ADDENDUM NO. 3

May 1, 2024

Blue River Valley Schools Renovations to:

Elementary School4713 Viking Trail
New Castle, IN 47362 **Jr. Sr. High School**4741 Viking Trail
New Castle, IN 47362

E-401

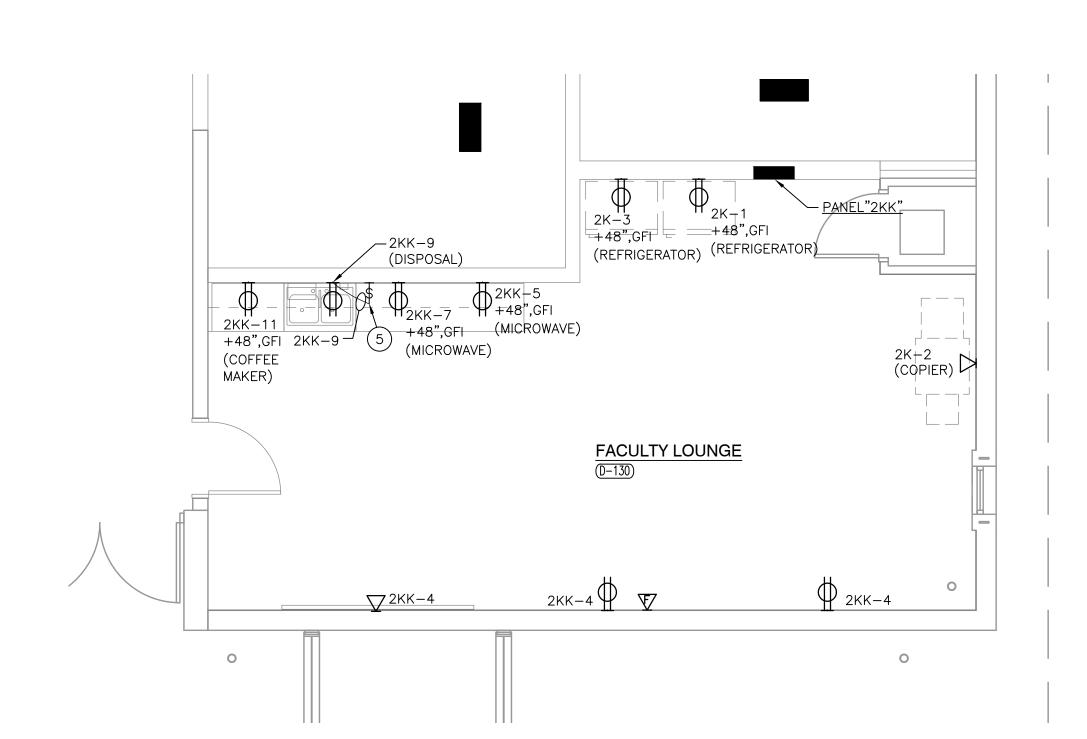
9. Sheet E-401

A. Refer to revised full size drawing included in this Addendum for revisions.

E-602

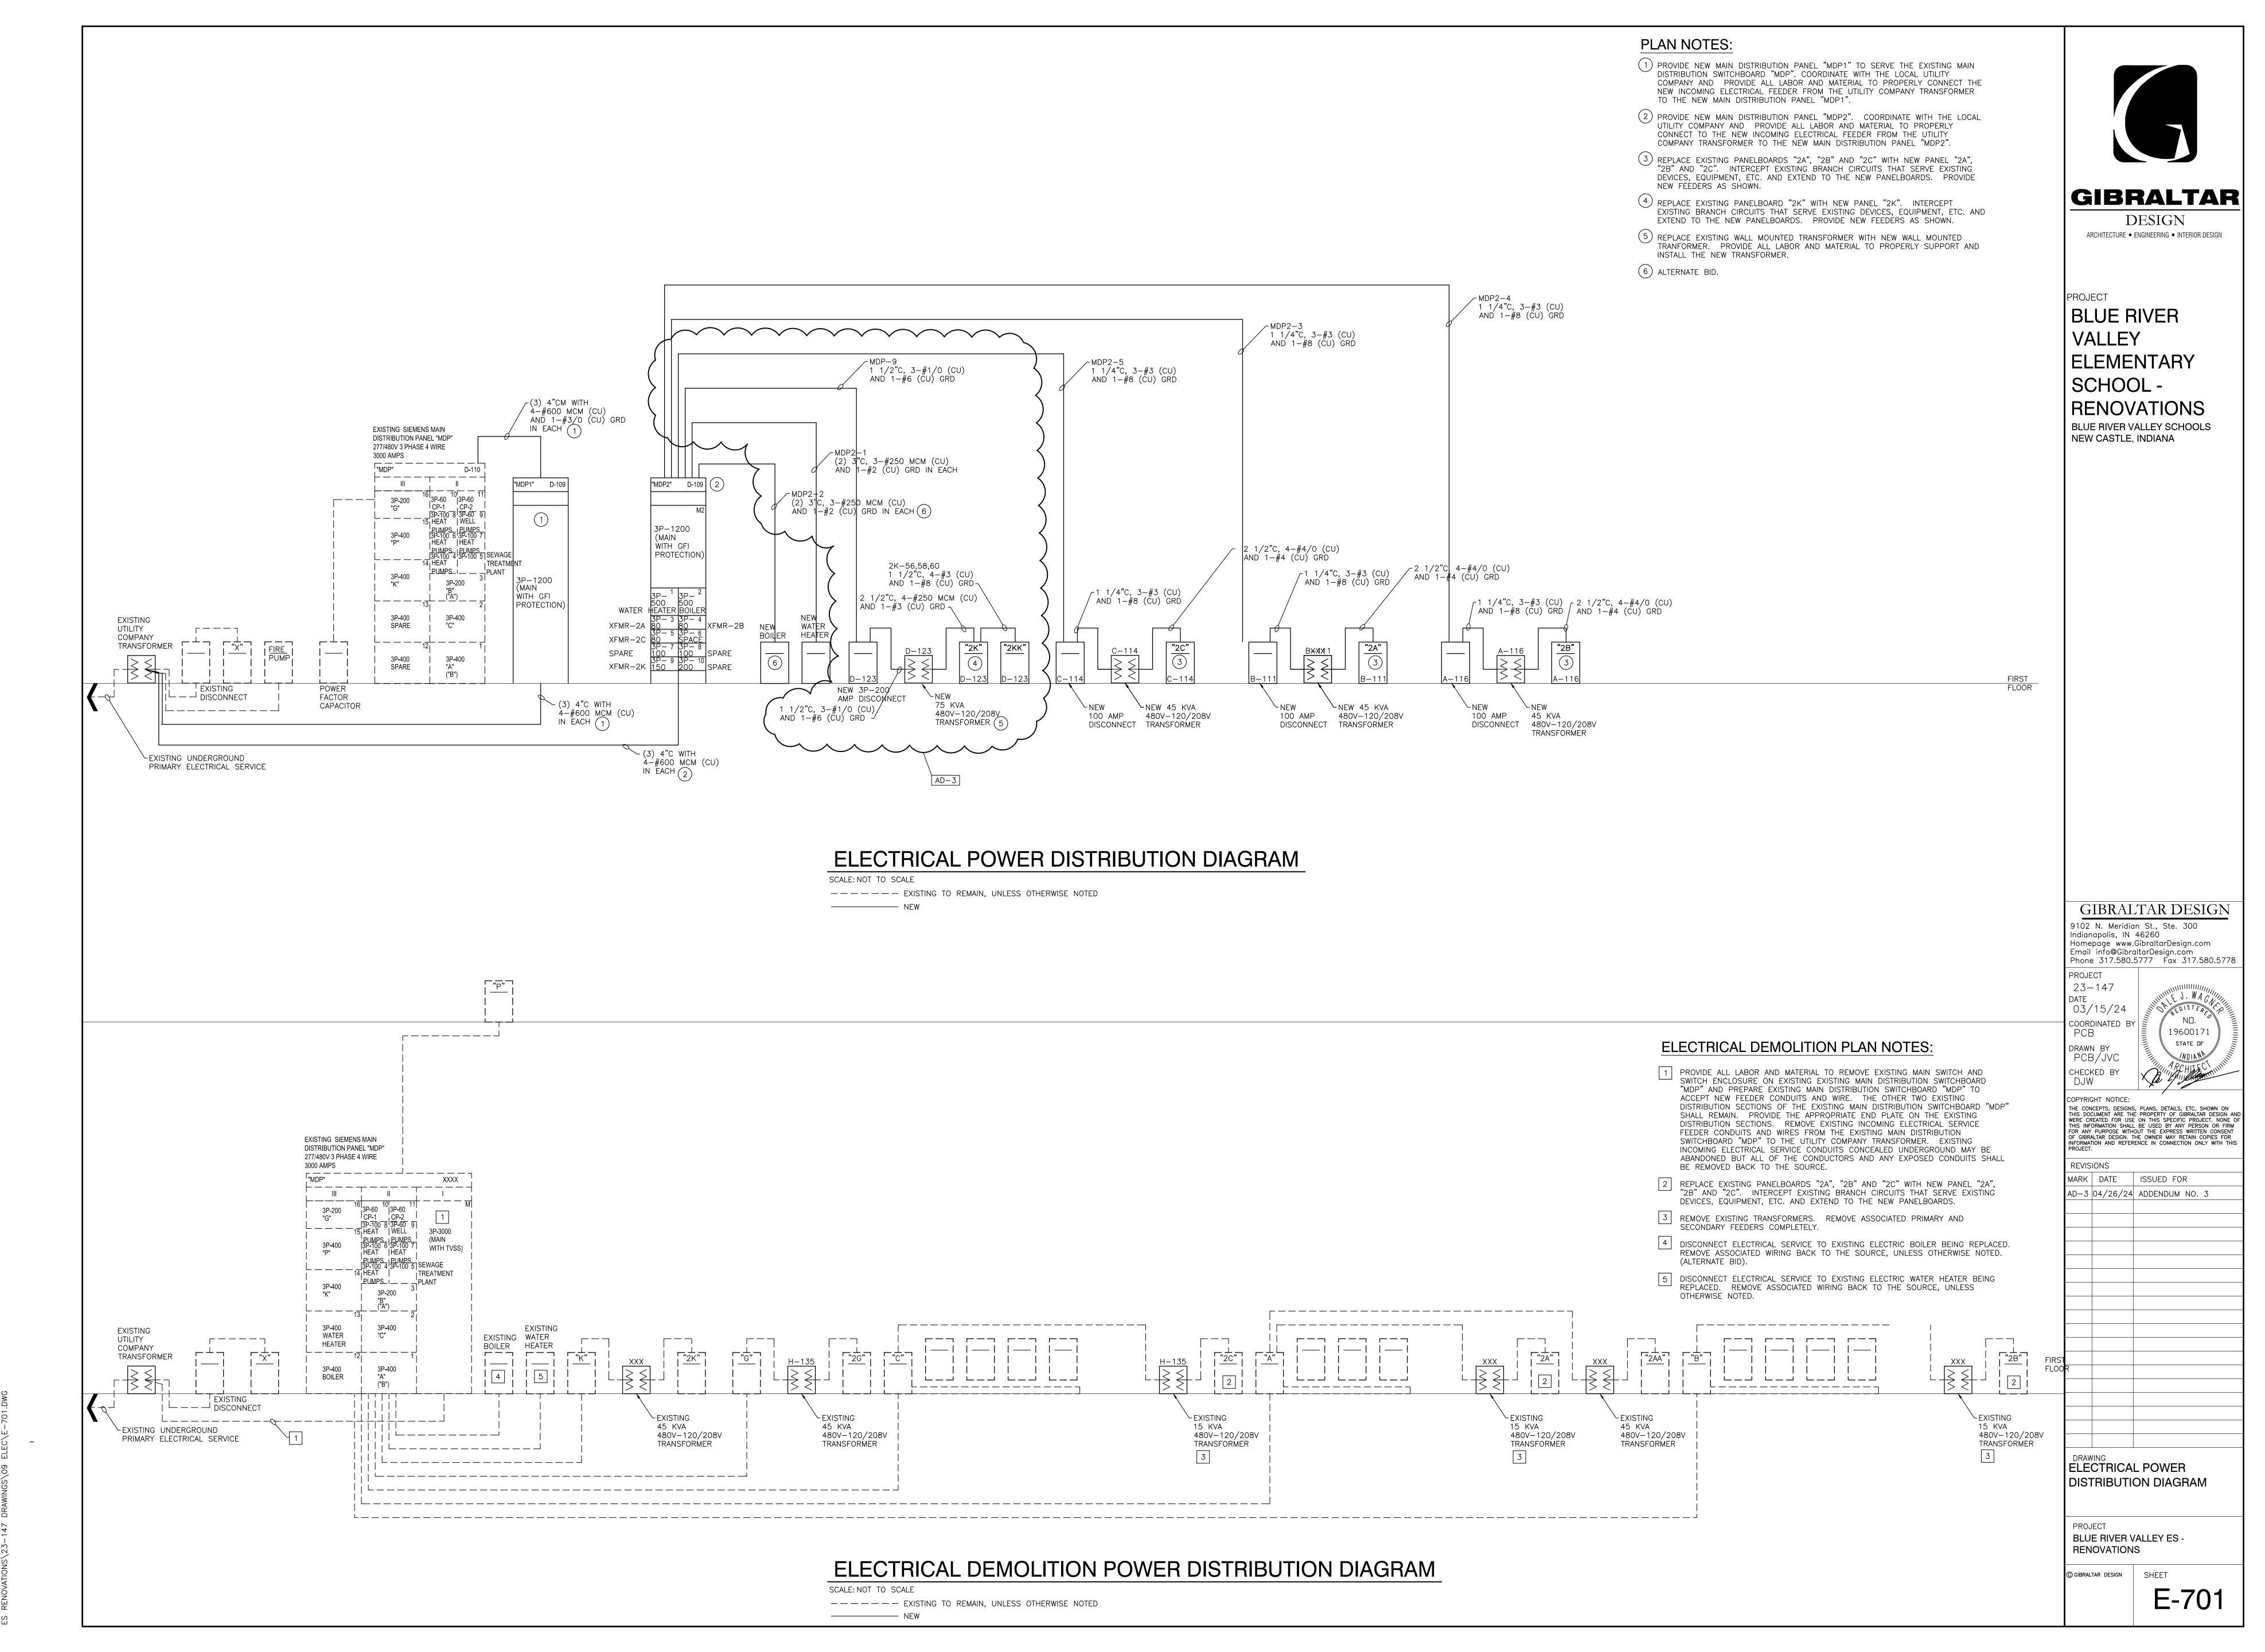
11. Sheet E-602

A. Refer to revised full size drawings included in this Addendum for revisions.

C-001

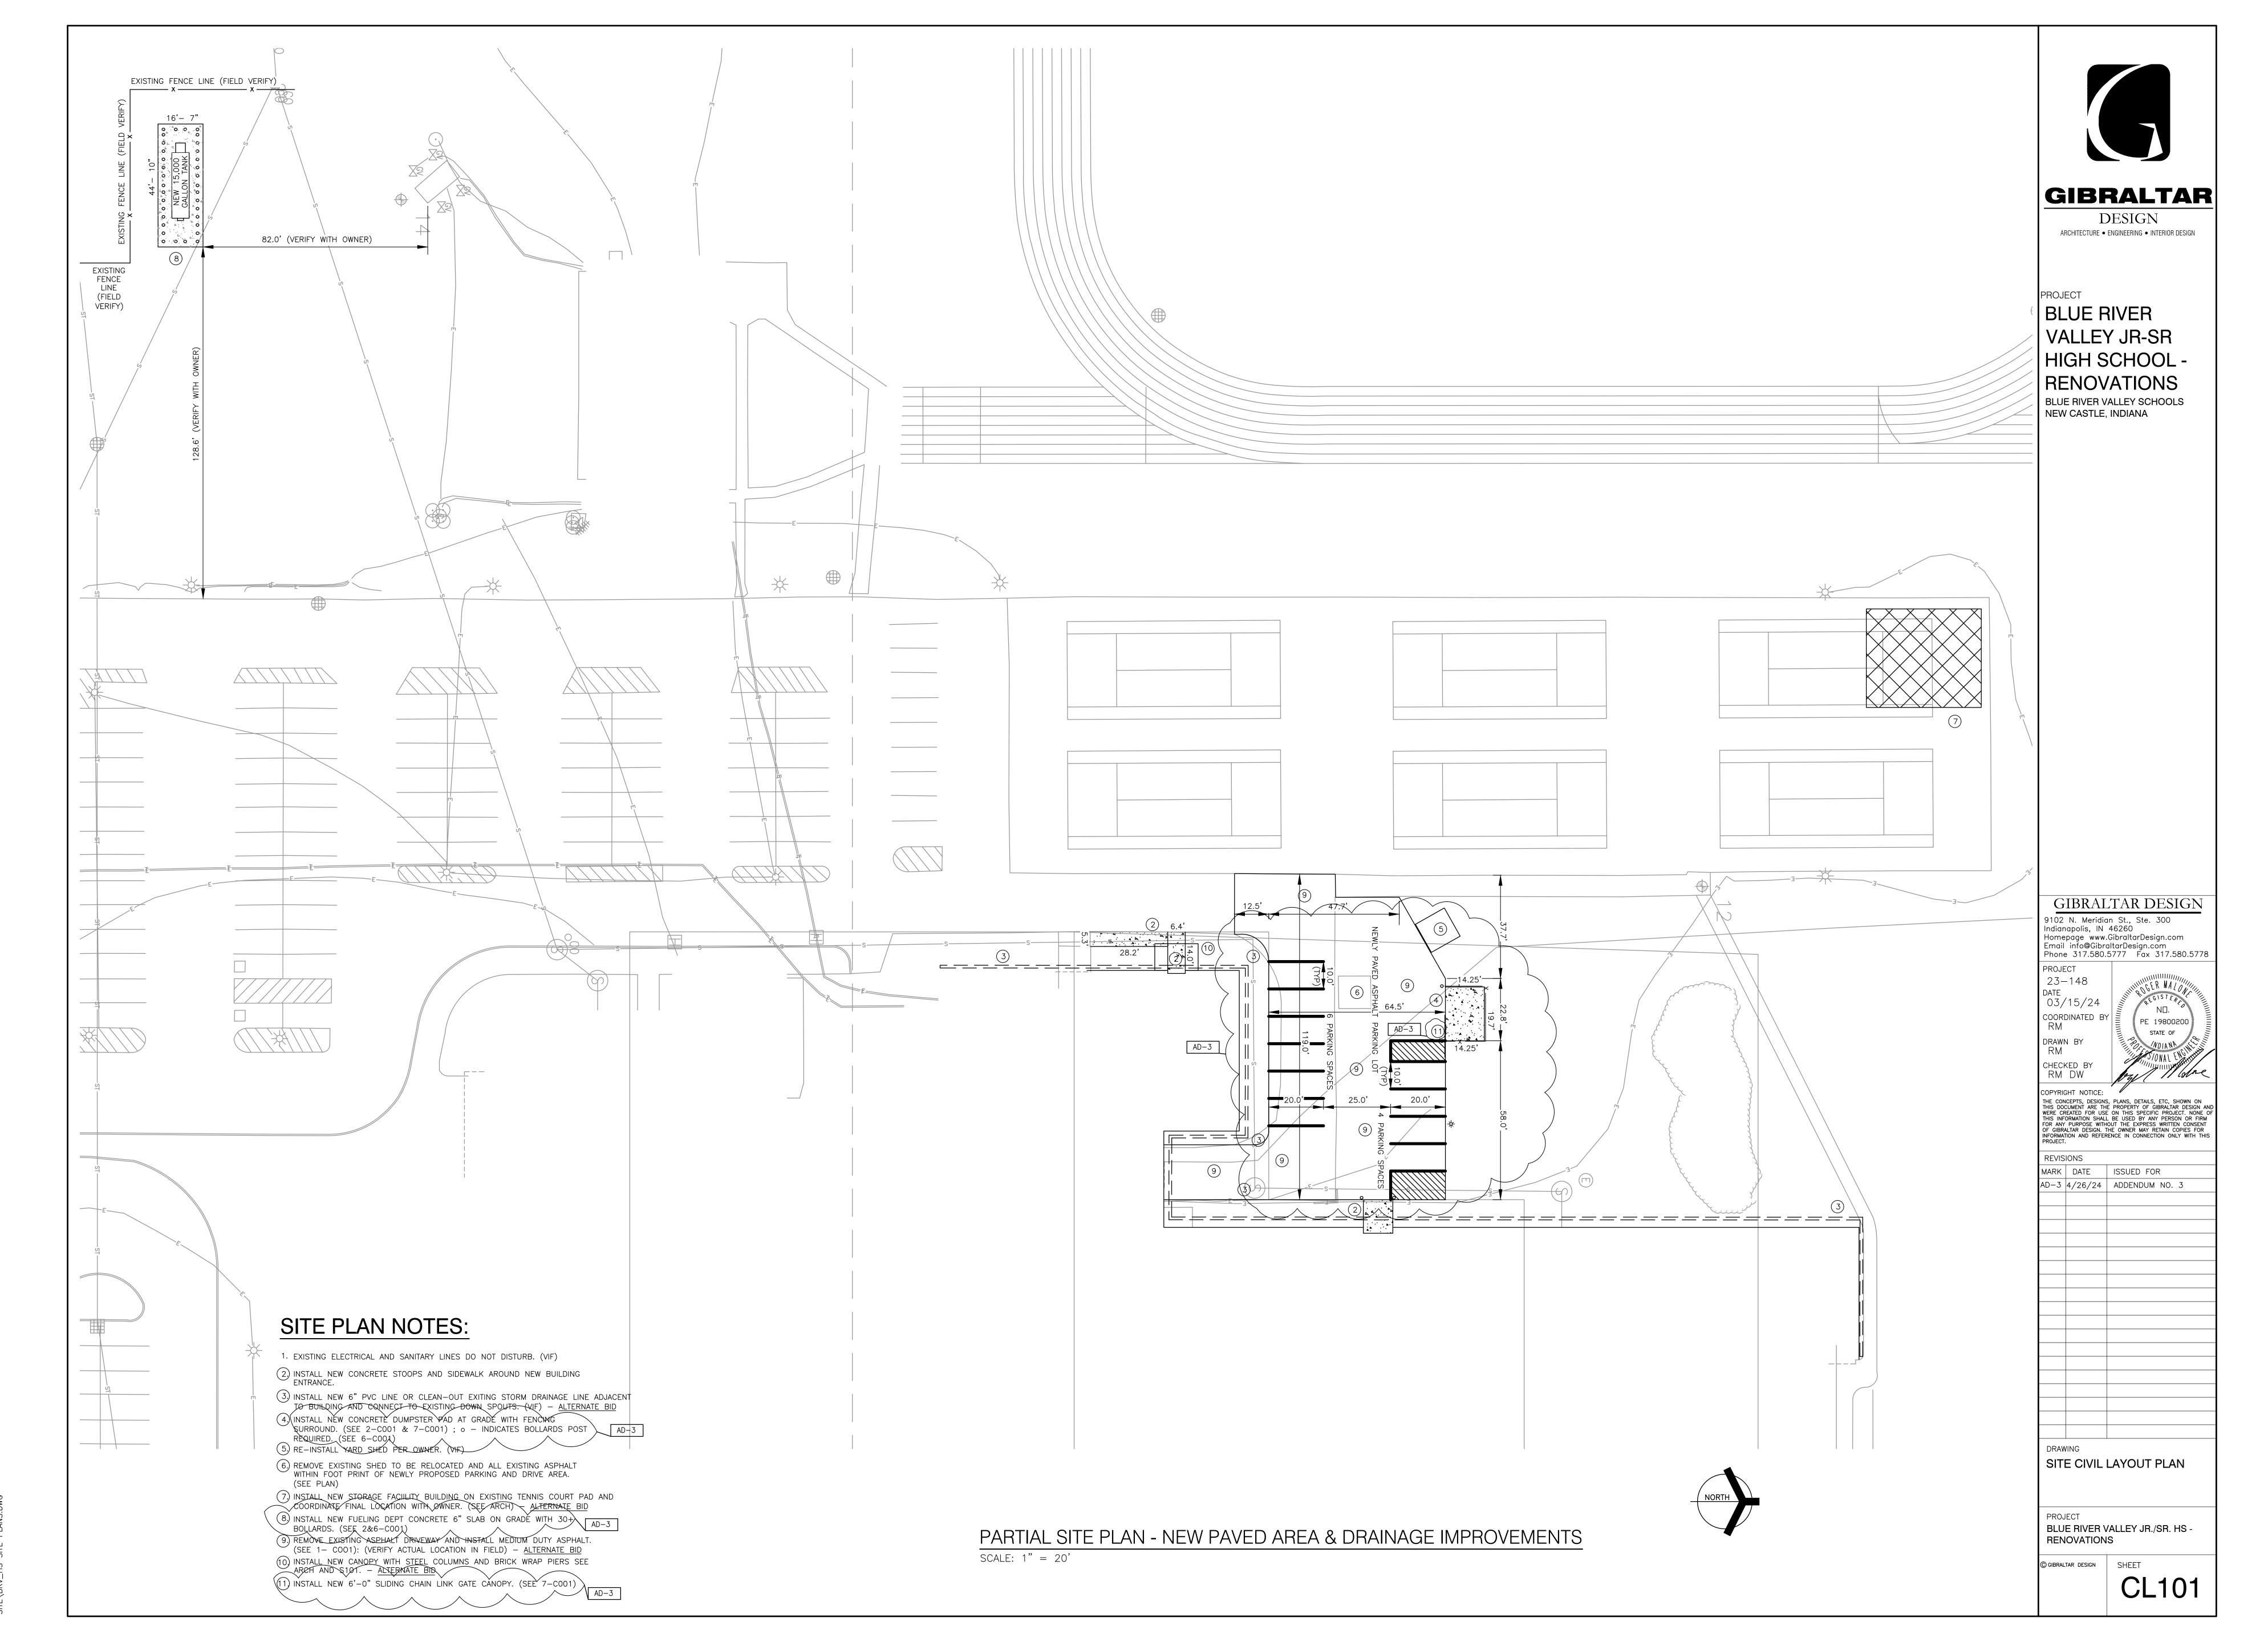
14. Sheet C-001

- A. Refer to revised full size drawing included in this addendum for the following revisions and additions:
 - 1. Add Detail 7/C001 showing chain link fence detail for dumpster pad area.
